Item Name: Crosstube Assembly, Mid Aft

A	NEW ISSUE	CP	10.12.23
REV.		BY	DATE
DESIGN	91	DART AEROSPACE LTD	
DRAWN	91	HAWKESBURY, ONTARIO, CANADA	
CHECKED	91	DRAWING NO.	REV. A
MFG. APPR.	91	D206-667-247	SHEET 1 OF 4
APPROVED	91	TITLE	SCALE
DE APPR.	91	CROSSTUBE ASS'Y (206L MID AFT)	NTS
DATE	10.12.23	COPYRIGHT © 2010 BY DART AEROSPACE LTD THIS DOCUMENT IS PROPRIETARY AND CONFIDENTIAL AND IS SUPPLIED ON THE EXPRESS CONDITION THAT IT IS NOT TO BE USED FOR ANY PURPOSE OR COPIED OR COMMUNICATED TO ANY OTHER PERSON WITHOUT WRITTEN PERMISSION FROM DART AEROSPACE LTD.

DRAWING NO. D206-667-247	TITLE CROSSTUBE ASS'Y (206L MID AFT)	REV. A	DART AEROSPACE LTD ENGINEERING ORDER		D.E.O. NO. D206-667-247-A-1	SHEET NO. SHEET 1 OF 1	SCALE NTS
DRAWN <i>Q</i>	CHECKED <i>ASS</i>	MFG. APPR. <i>KS</i>	APPROVED <i>AMP</i>		DE APPR. <i>#</i>		
DATE 11.07.15	DATE 11.07.20	DATE 11.07.21	DATE 11/07/21		DATE 11.07.21

PURPOSE:

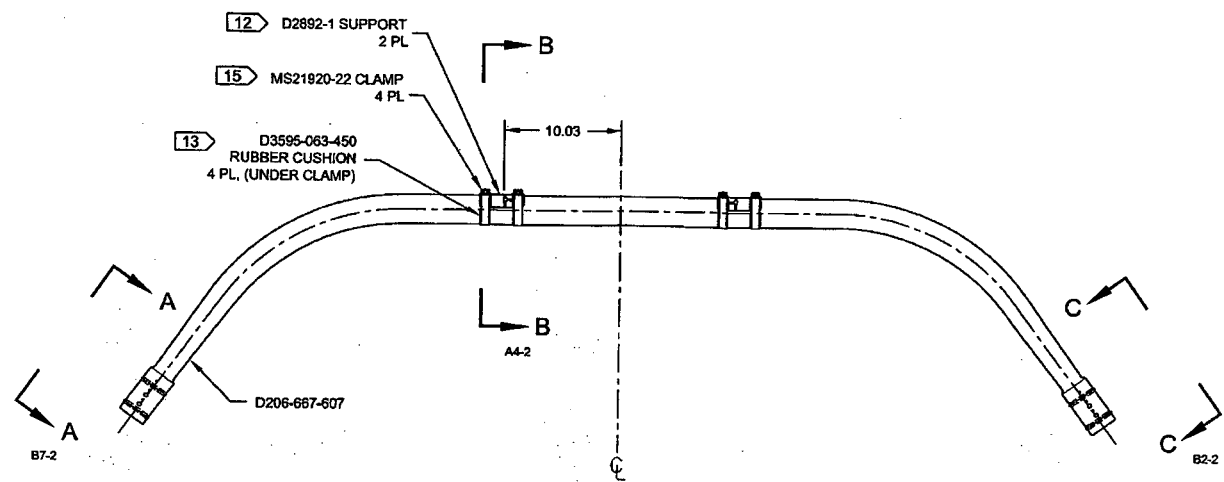
REPLACE MAGNOBOND WITH PROSEAL.

NOTE 12 & 15, SHEET 1 IS AMENDED AS FOLLOWS:

WAS:

- 12) INSTALL D2892-1 SUPPORT USING 0.03" TO 0.06" THICK LAYER OF MAGNOBOND 6398 PER QSI 015. LET CURE FOR 12 HOURS AFTER INSTALLATION AND PRIOR TO PACKAGING.
- 15) TORQUE CLAMPS 80 TO 100 IN-LB. ENSURE AT LEAST 1.5 THREADS SHOWING IN SAFETY AND THAT NUT HAS NOT BOTTOMED-OUT AFTER TORQUING.

Item	Qty -247	Part Number	Description
9	A/R	PROSEAL 890 B-2	SEALANT, AMS-S-8802 CLASS B-2

- 12) TO INSTALL D2892-1 SUPPORT: ABRASE MATING SURFACE OF SUPPORT AND CROSSTUBE WITH 180-GRIT SANDPAPER AND REMOVE RESIDUE WITH MEK (OR EQUIVALENT). APPLY A 0.04" TO 0.07" THICK LAYER OF PROSEAL 890 CLASS B-2 (OR AMS-S-8802 CLASS B-2) SEALANT TO MATING SURFACE OF SUPPORT.
- 15) TORQUE CLAMPS 80 TO 100 IN-LB. ENSURE AT LEAST 1.5 THREADS SHOWING IN SAFETY AND THAT NUT HAS NOT BOTTOMED-OUT AFTER TORQUING. **PRIOR TO PACKAGING, RE-CHECK TORQUE ON CLAMPS AFTER PROSEAL 890 SEALANT HAS CURED FOR 72 HOURS.**
